Planning Commission Meeting

March 11, 2025 6:00 PM

4.I. 3406 North Fulton Circle Final Plat Review

PLANNER'S REPORT

SUBDIVISION SURVEY FOR:

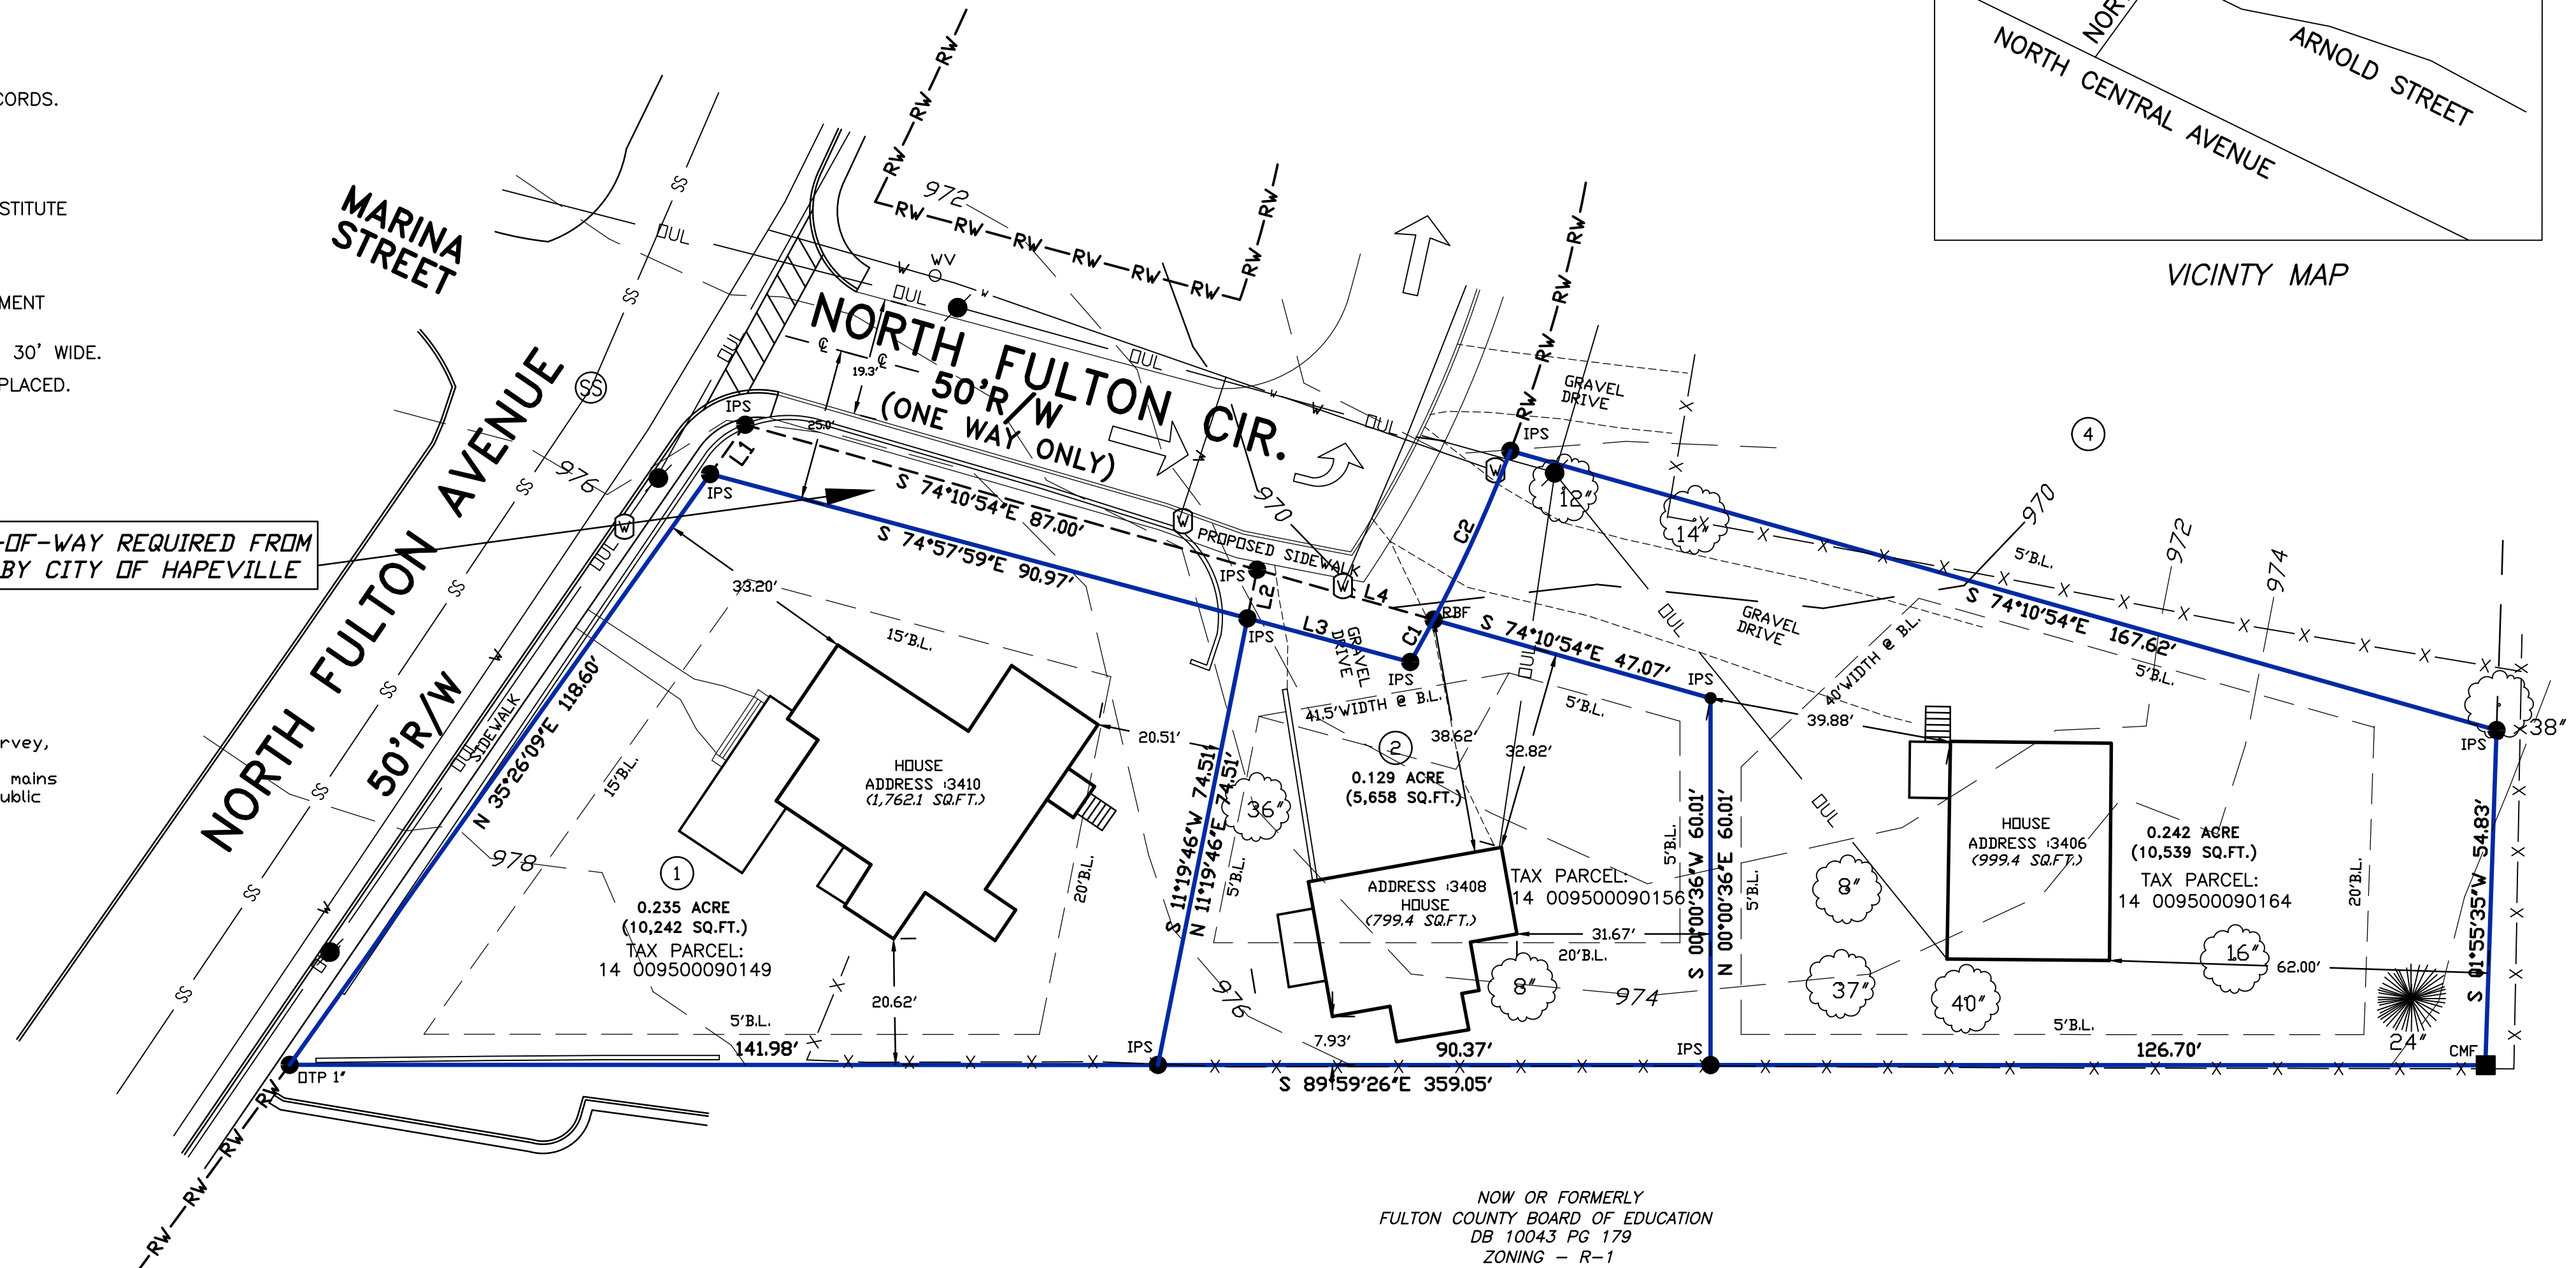
- **Monuments should be shown on the plat.**
- (2) Grading. All streets, roads and alleys shall be graded to their full width by the subdivider so that pavements and sidewalks can be constructed on the same level plane. Due to special topographical conditions, deviation to the above will be allowed only with special approval of planning commission.

Not addressed on plan.

- r. Street trees are required as a part of the development of each lot. The site plans for each lot must include a street tree and tree conservation plan in accordance with City ordinance requirements. Please indicate this on the plat.

- 1. Provide the missing signature for one of the purchasers, Dawit Makonnen, for the subdivision plat and for the Planning Commission application. The signature of all three property owners is required for any approval, conditional or otherwise.

- 3. Monuments should be shown and installed for the proposed subdivision as directed above.
- 4. The Planning Commission may waive the requirement for sidewalk installation.
